**Pre-filed Direct Testimony of
John C. Case**

**COMMONWEALTH OF MASSACHUSETTS
ENERGY FACILITIES SITING BOARD**

)	
)	
Western Massachusetts Electric Company)	EFSB 08-2/D.P.U. 08-105/D.P.U. 08-106
)	
)

PRE-FILED DIRECT TESTIMONY OF JOHN C. CASE

Northeast Utilities Service Co.		FOR GREATER SPRINGFIELD RELIABILITY PROJECT			
		TITLE FAIRMONT SWITCHING STATION TRANSMISSION LINE GREENFIELD CONCEPTUAL LAYOUT CHICOPEE, MA			
BY	PMW	CHKD	TAT	APP	APP
DATE	9/05/08	DATE	9/05/08	DATE	DATE
SCALE	NONE	SIZE	B	DWG. NO.	
PROJ.	V.S.			FIGURE 2

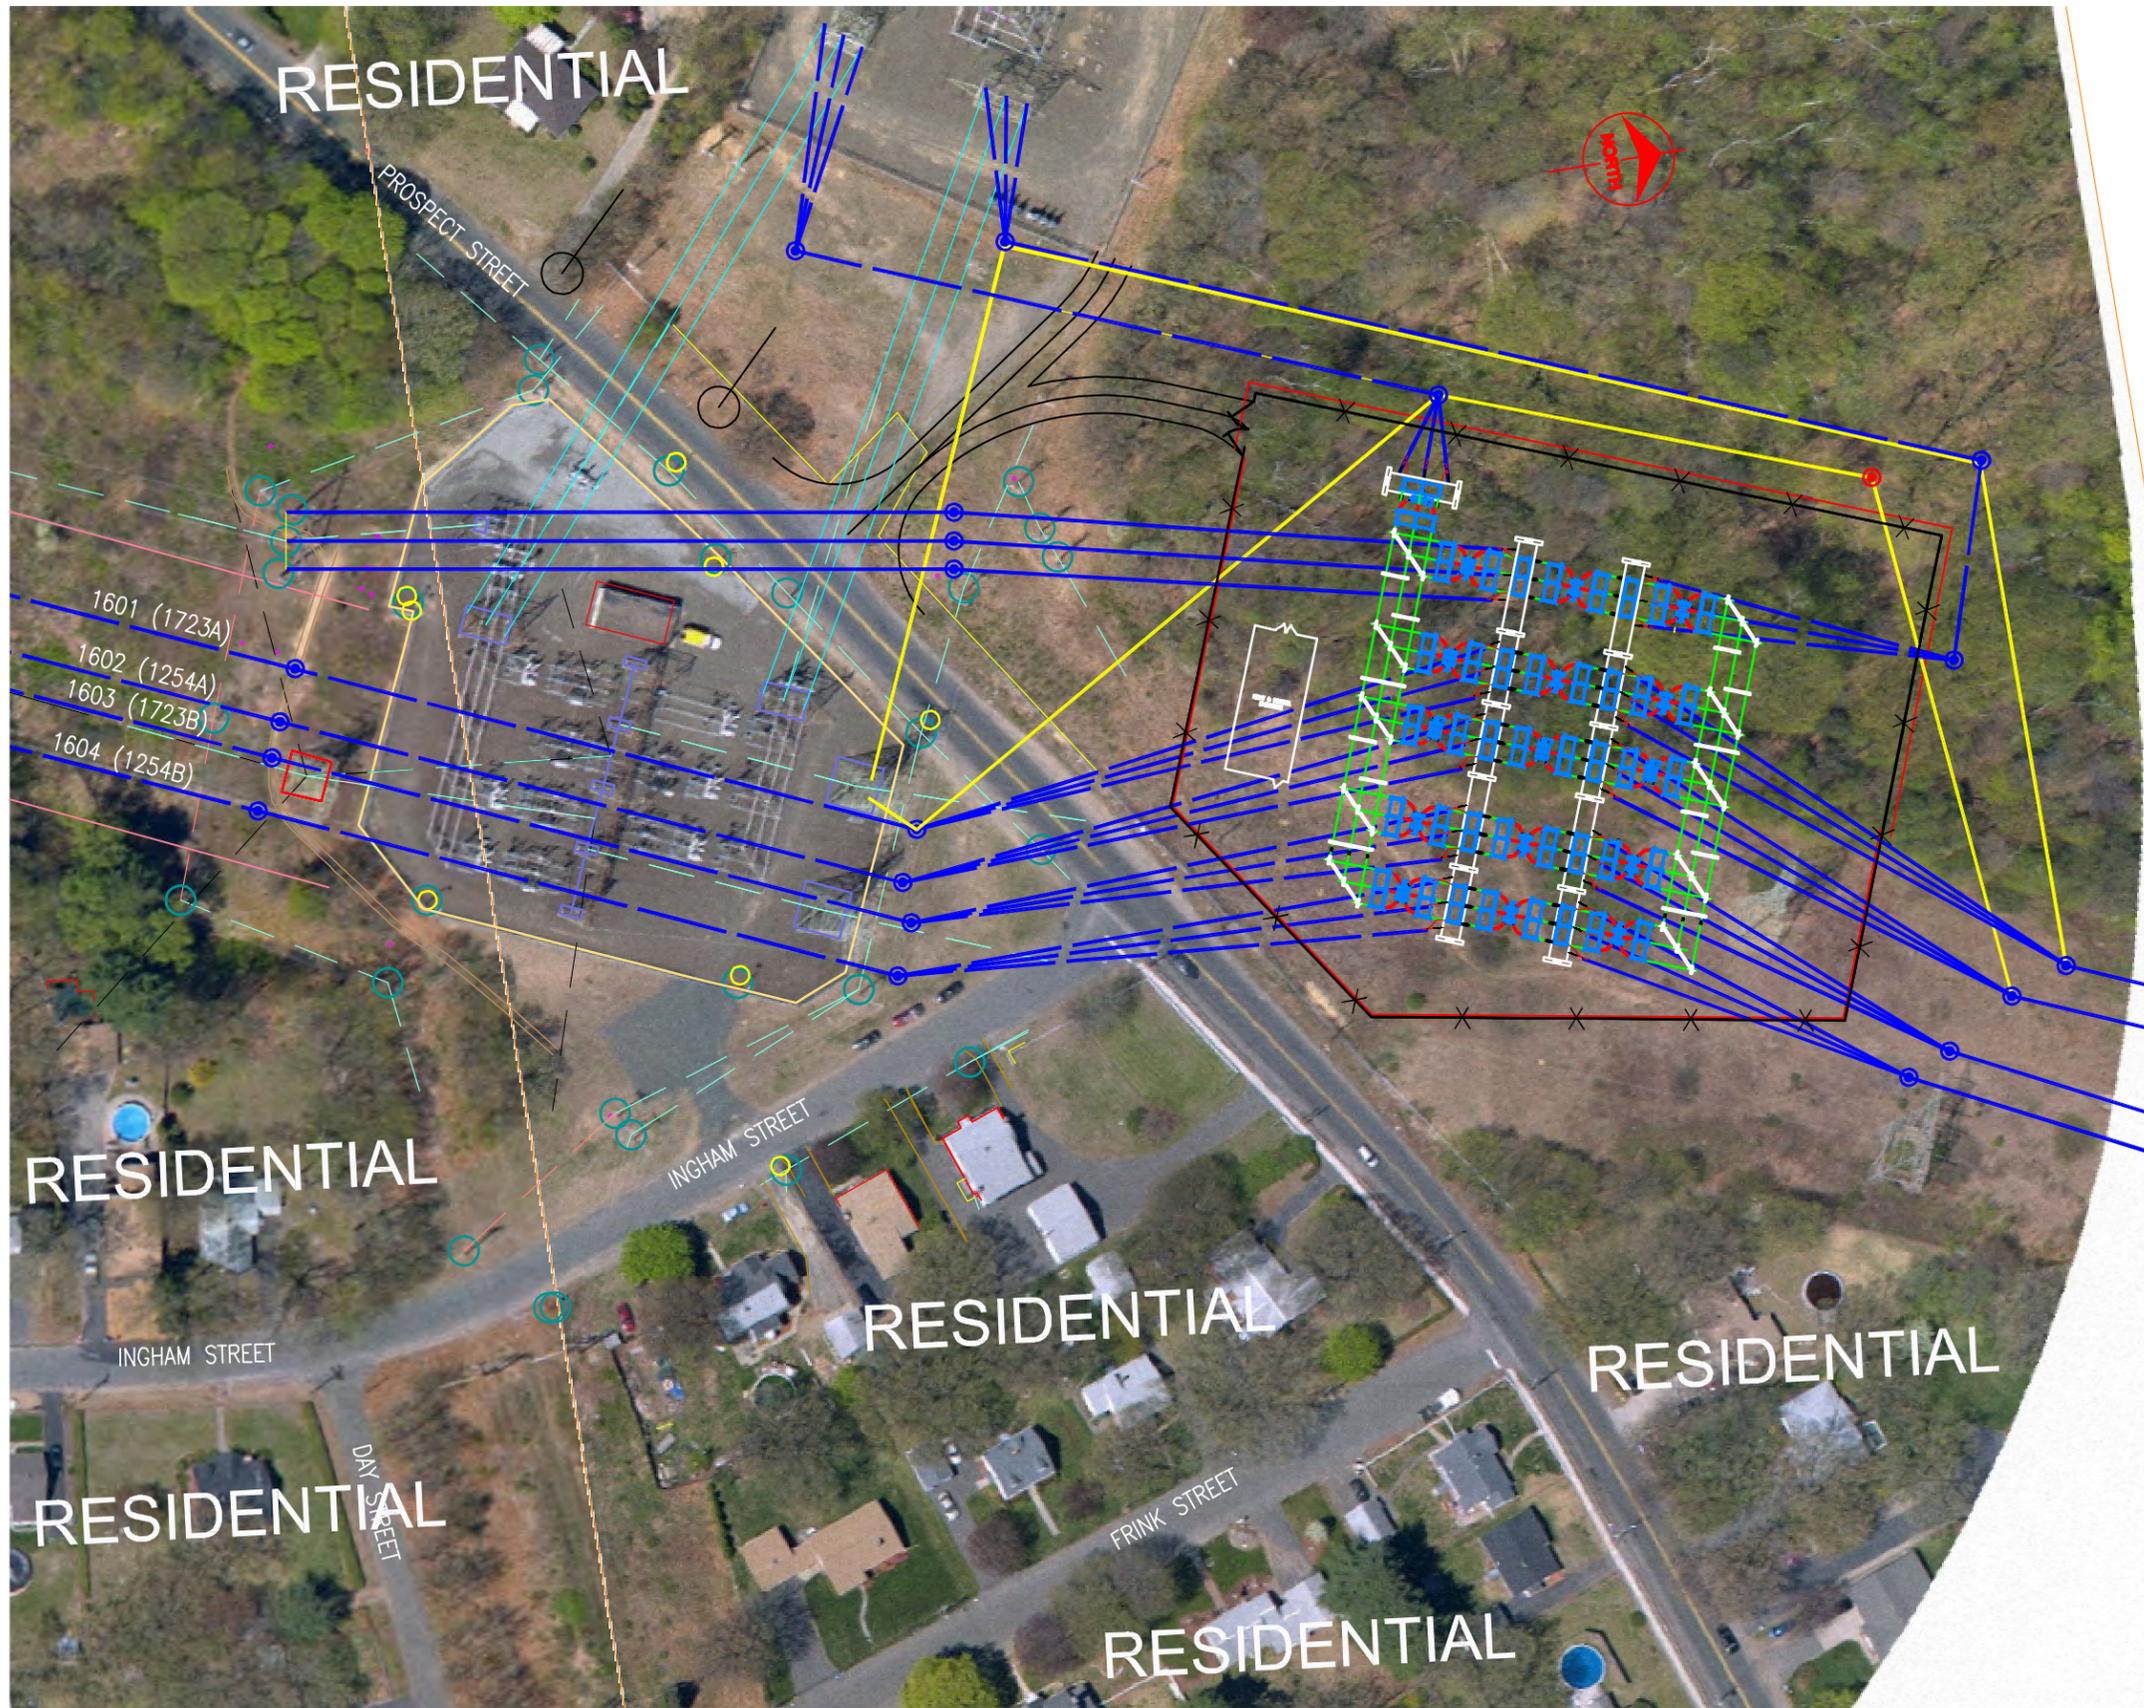
18 A. As described earlier, an agreement in principal for the sale of the property proposed for the
19 new Fairmont Switching Station has been reached by the current landowner, Holyoke Gas
20 and Electric. The design of the station remains primarily as it was proposed in the Petition;
21 however, the latest plan is attached to show the status of the design. Requirements have been
22 further refined to show the civil work required at the site. This drawing is attached as Exhibit
23 WMECO-JCC-6.
24
